**RESOLUTION NO. 1237**

**A RESOLUTION AMENDING THE OFFICIAL ZONING MAP TO APPLY PLANNED DEVELOPMENT INDUSTRIAL ZONING AND ADOPTING CONDITIONS APPROVING STAGE I AND STAGE II SITE DEVELOPMENT PLANS FOR A GARDEN CENTER TO SELL AND DISPLAY NURSERY STOCK AND OPERATE A RETAIL FLORAL SHOP. THE SITE IS IDENTIFIED AS BEING TAX LOT 700, TM3-1W, 11D, WILSONVILLE, CLACKAMAS COUNTY, OREGON. EBY INVESTMENTS, LTD., APPLICANT.**

PLANNING DEPARTMENT  
STAFF REPORT

REQUEST: 95PC29 Wilsonville Garden Center. The applicant seeks APPROVAL OF a zone map amendment to convert Residential Agriculture - 1 acre minimum (RA-1) to Planned Development Industrial (PDI), approve a Stage I preliminary plan. Stage II, final site development plans for a retail garden center. Being that the proposed zoning is Planned Development Industrial (PDI), the applicant seeks to utilize provisions of the code allowing outdoor storage of inventory as industrial storage. In this case, outdoor inventory comprising of plant materials and garden supplies. Retail commercial would then be conducted in the new building.

EXHIBIT  
C-4

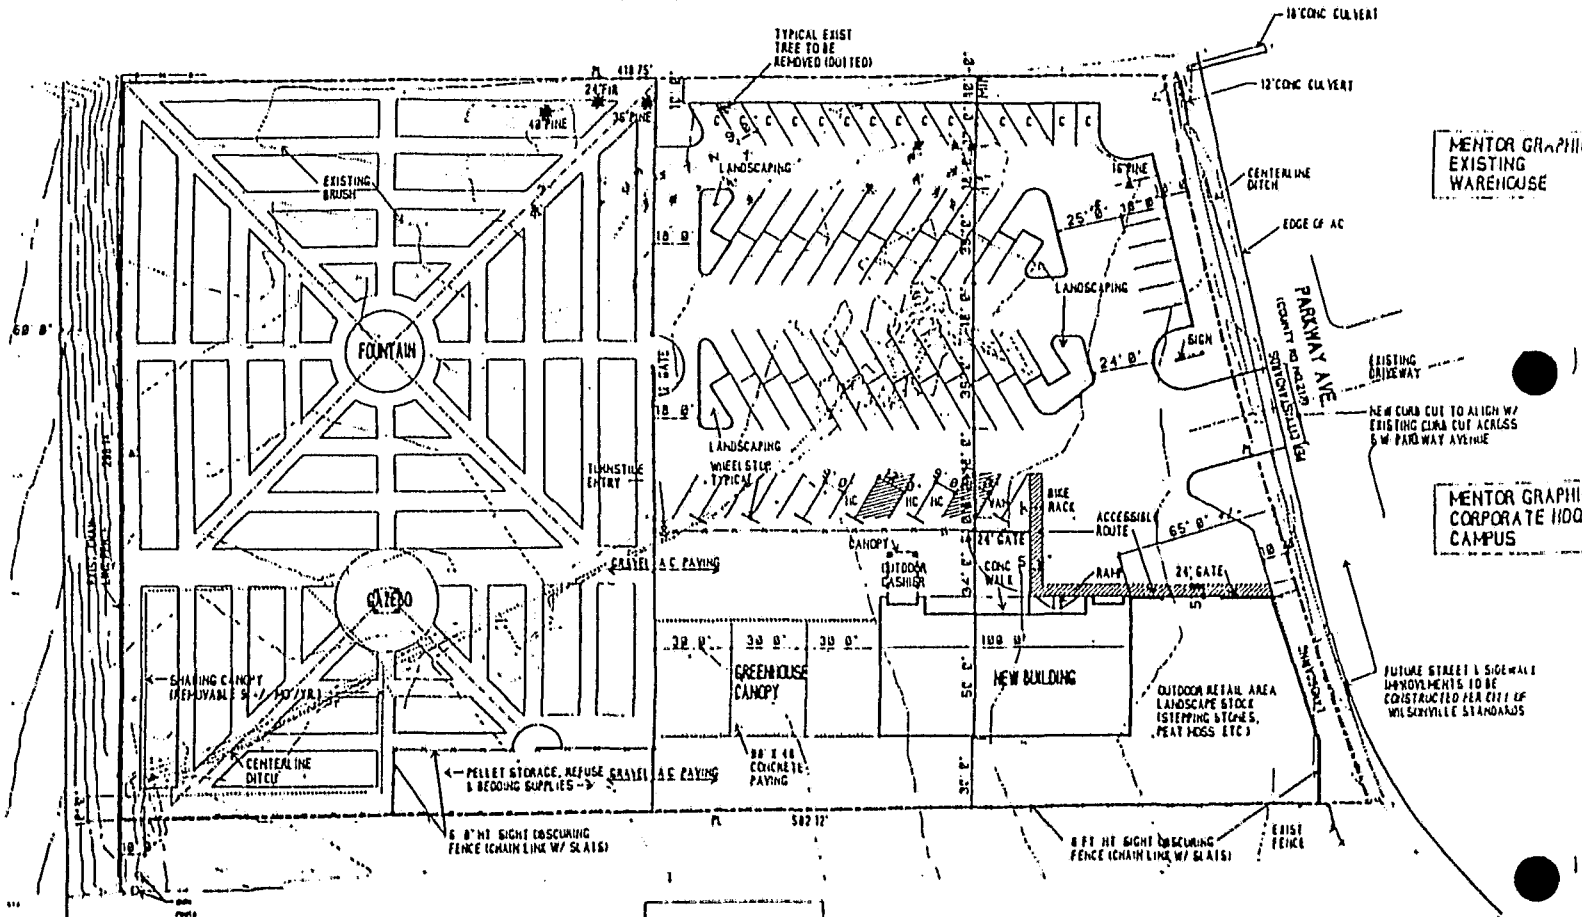
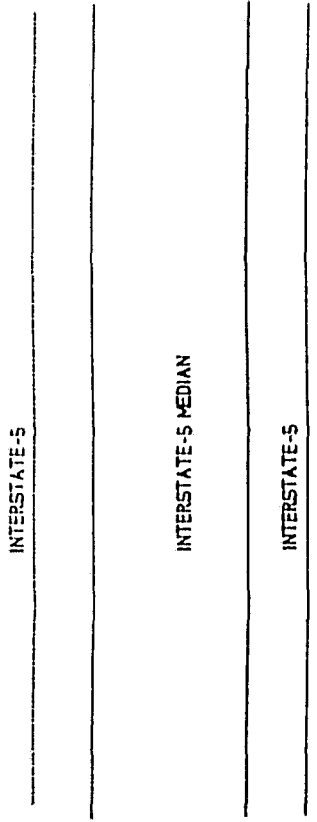
Regarding the above, a 5' wide concrete sidewalk is required to follow along Parkway Avenue. The site plan does not show sidewalk improvements. The Bicycle and Pedestrian Master Plan shows an on-street, 5 to 6' wide bike lanes on both sides of Parkway Avenue.

Regarding the above, along the north property line are several pines and Douglas firs. The trees range in size from small to 40" diameter. In spite of staff's request to save trees until the DRB public hearing, several significant pines were recently harvested along the northerly property line to make room for anticipated storm drainage and site improvements. At least twelve (12) trees shown on the site plan could have been preserved and integrated into the parking lot design.

5. Construct a temporary, three (3) -foot wide gravel walk, to follow along the entire length of the property fronting Parkway Avenue to be constructed prior to occupancy.

11. The applicant shall provide the Design Review Board a tree replacement plan for trees removed along the north property line.
